Service Letter No. 400

SUBJECT: Tail Brace Rods

MODELS AFFECTED: All PA-12, PA-14 and PA-20 Aircraft and
PA-22 Tri-Pacer Aircraft Serial Nos. 22-1 to 22-7999 incl.

FIN TIE ROD ATTACHMENT

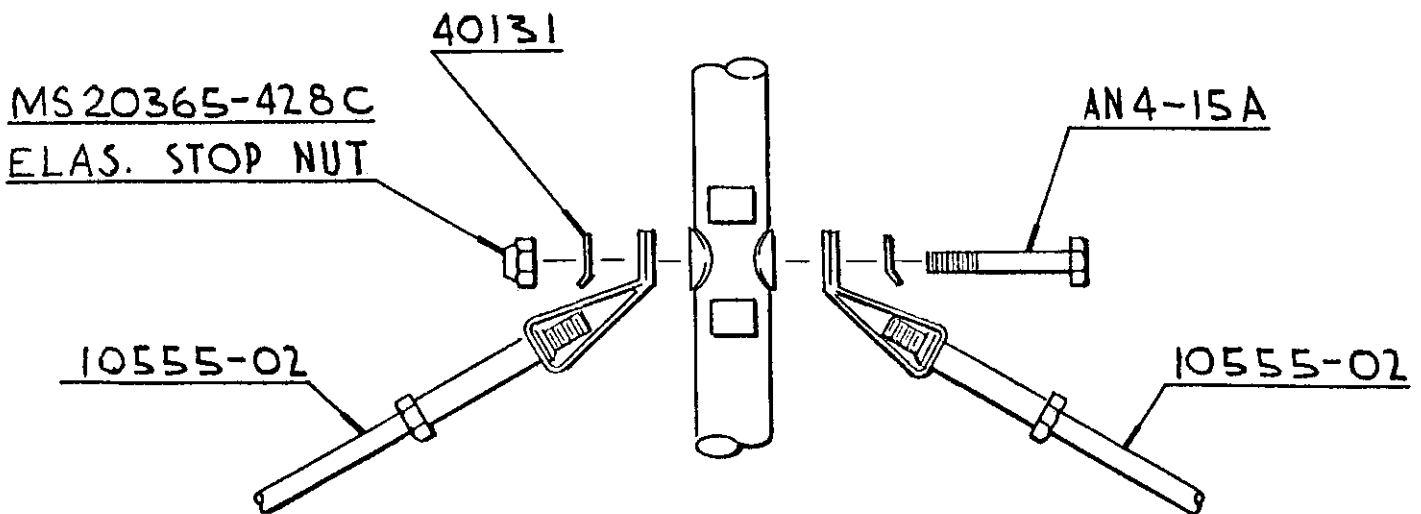
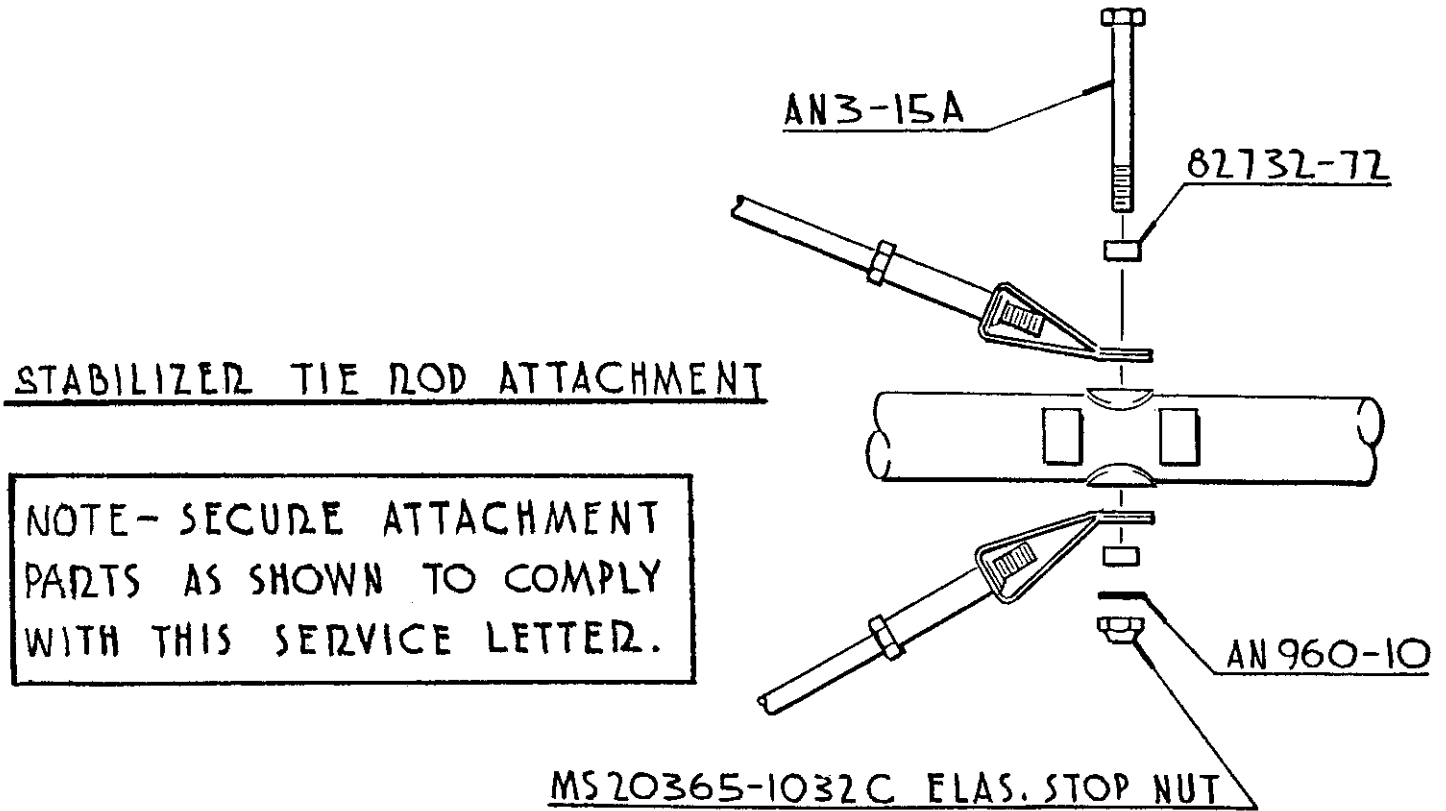
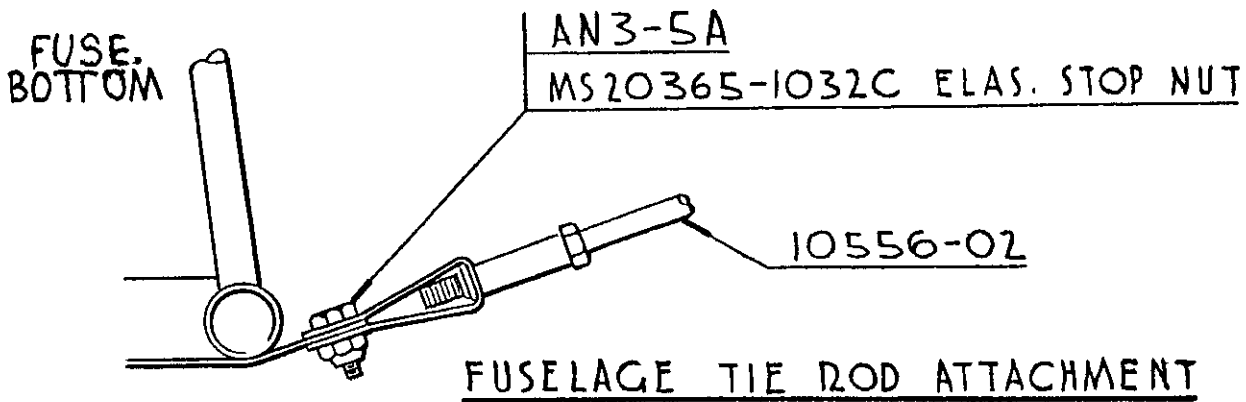
We wish to announce that the round upper and lower tail brace tie rod assemblies, part numbers 10555-02 and 10556-02, respectively, have been approved to replace the upper and lower streamline tail brace tie rod assemblies, part numbers 10074-02 and 10074-03, on PA-12, PA-14, PA-20 and PA-22 aircraft, serial numbers listed above.

The installation of the round tail brace tie rods will eliminate compliance with Piper Service Bulletin No. 183 and F.A.A. AD-60-1-7. Therefore, it is recommended that as the streamline tie rods are retired from service, the round tie rods be installed as a replacement. See Sketch on reverse side for complete details.
